**From:** [Roger Clark](#)  
**To:** [Lisa Olson](#)  
**Subject:** FW: Proposed shopping center at Laurel Rd and Jacaranda Blvd  
**Date:** Monday, December 16, 2024 3:12:44 PM  
**Attachments:** [image001.png](#)  
[image002.png](#)  
[image003.png](#)  
[image004.png](#)  
[image005.png](#)

The North Venice Neighborhood Alliance submits this statement in opposition to the site plan petition of Border and Jacaranda Holdings, LLC, Petition No. 22-40SP. Seven copies of this statement with all referenced attachments will be provided to the planning and zoning department on Tuesday, December 31, for inclusion in each member's hearing packet.

THE NORTH VENICE NEIGHBORHOOD  
ALLIANCE'S SUBMISSION IN  
OPPOSITION TO SITE PLAN  
PETITION NO. 22-40SP

Exhibit 6:  
Site Photographs

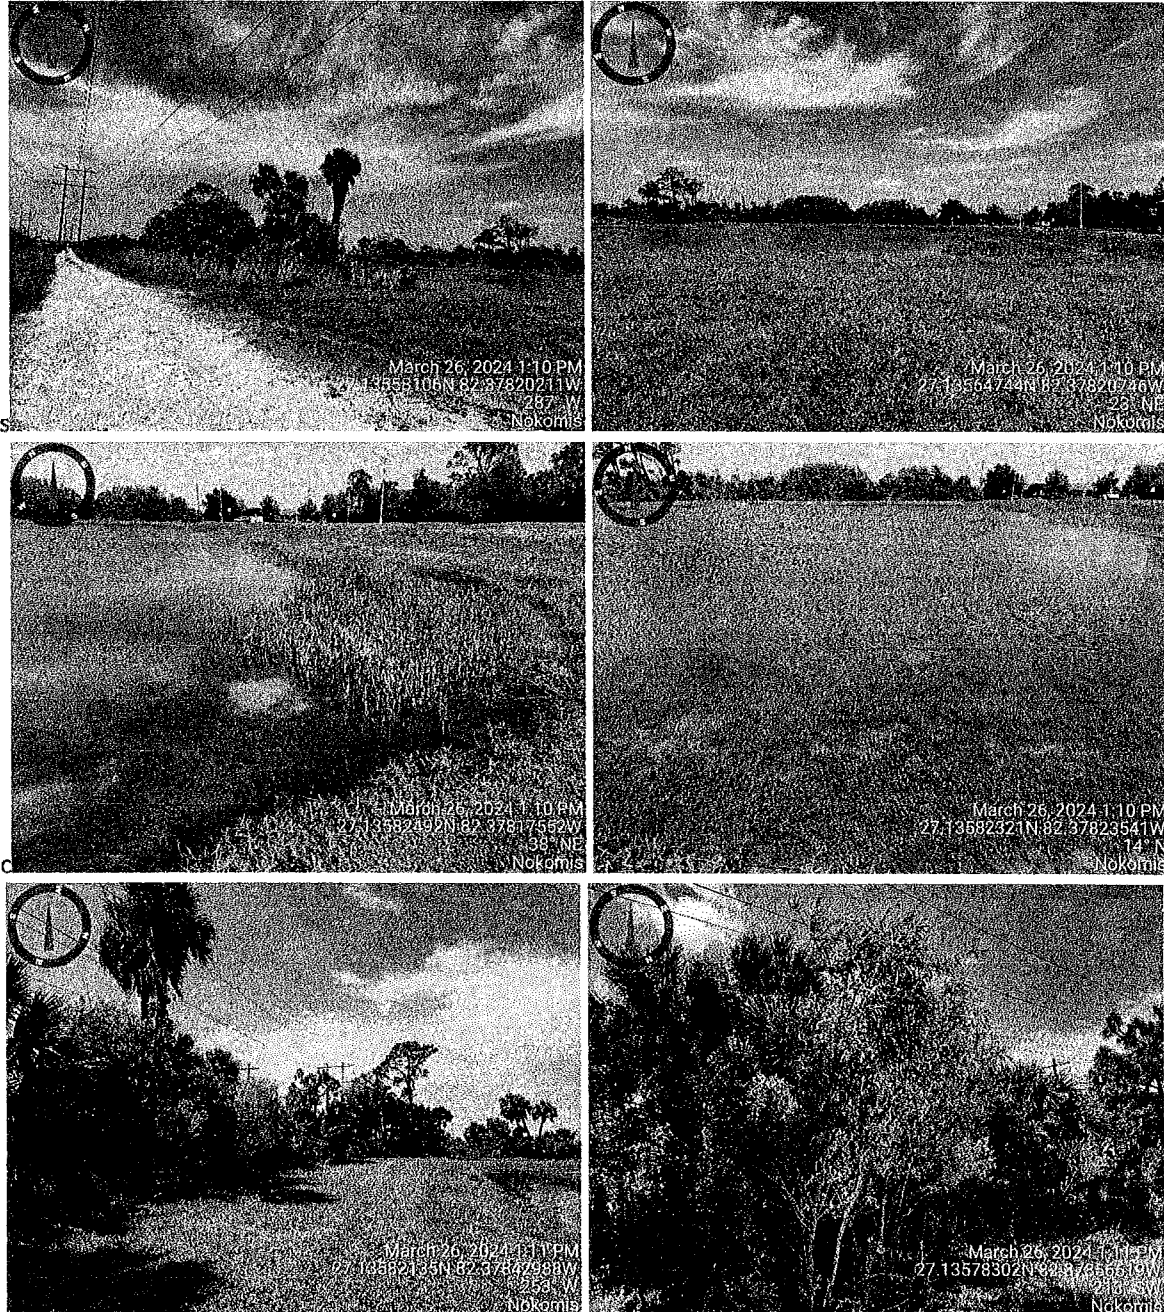
Fill pond and upland area

Wetland Area:

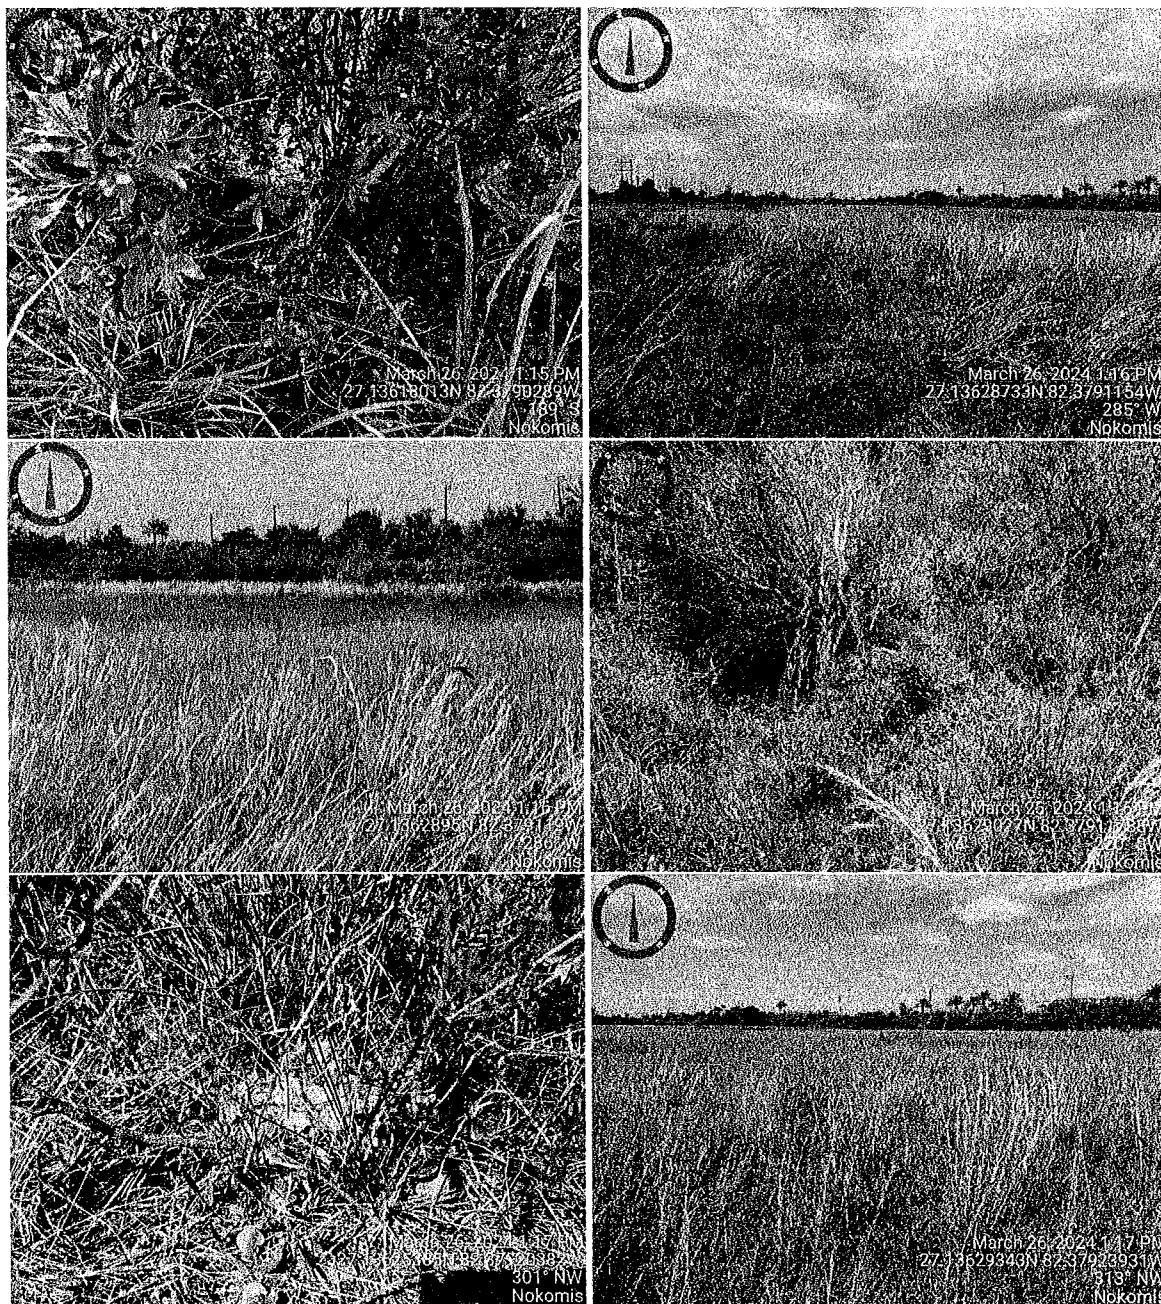
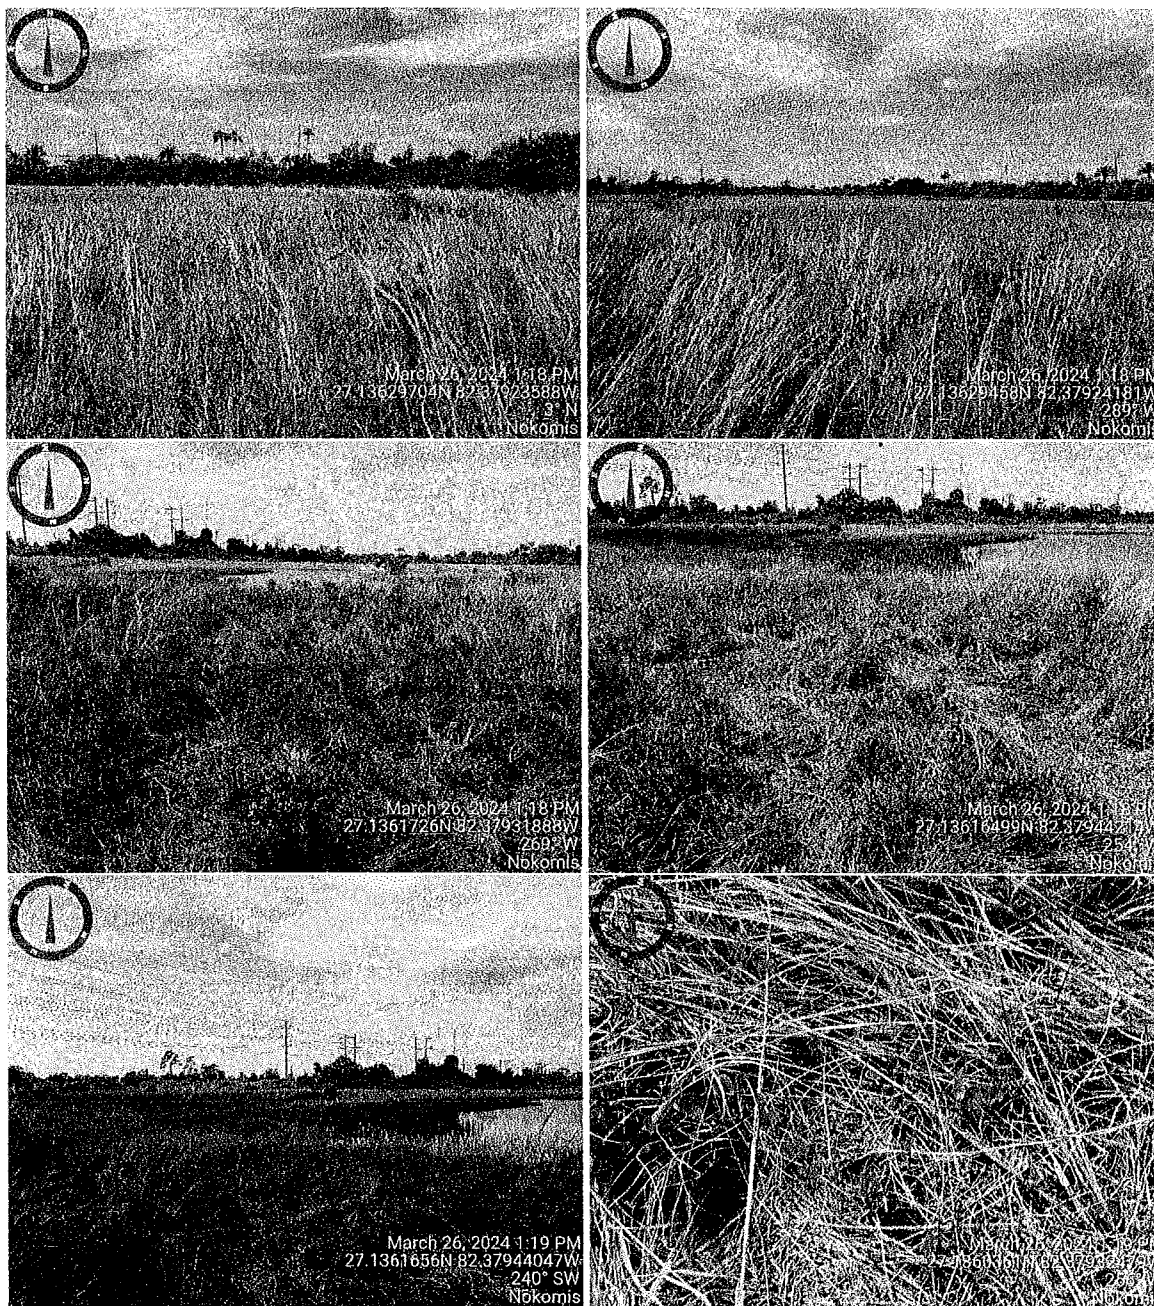
Evident depressional wetlands on the parcel persist throughout area development with little apparent change in hydrology from earliest aerial imagery through current condition.
